Technical Bulletin

Bulletin No: TCH-022-003

Subject: IMPROVED PARTS IDENTIFICATION FOR BENDIX® RSD REPLACEMENT CAMSHAFTS

Figure 1 – S-Cam Part Number Location

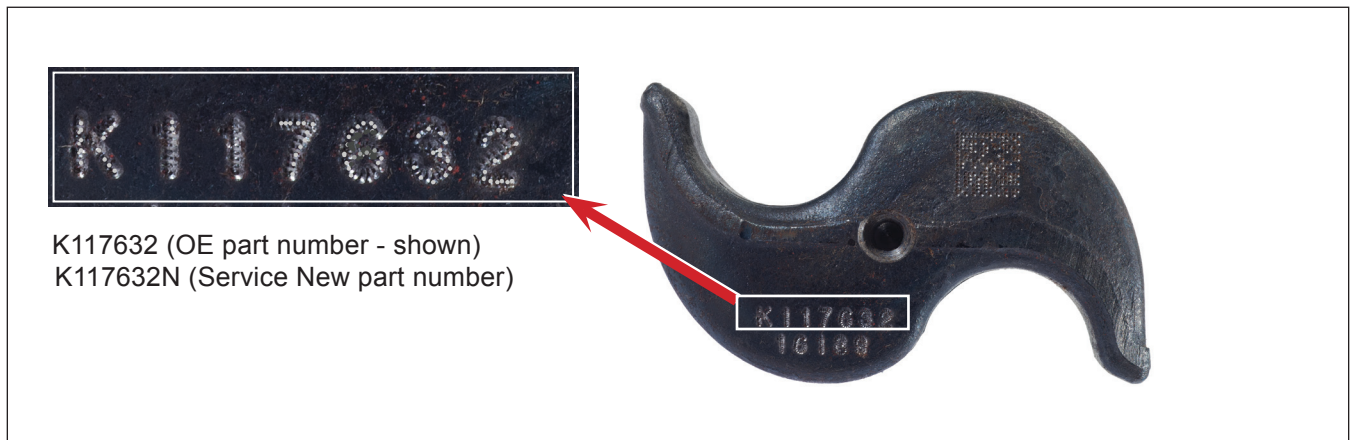
To make it easier for drum brake customers to identify the correct service replacement camshaft, Bendix is now stamping the camshaft part number on the head. This process is done in production for both 10- and 28-tooth camshafts. See *Figure 1*.

The suffix “N” on the part number denotes that this is a service new part. Part numbers ending in even numbers (e.g. K117632N) are for the left hand camshafts (rotation is counterclockwise), and those ending in odd numbers (e.g. K117633N) are for the right hand camshafts (rotation is clockwise). See *Figure 2*.

Also, to ensure the camshaft is a genuine Bendix® part, “BENDIX” is now stamped on the inside of the cam head. See *Figure 3*.
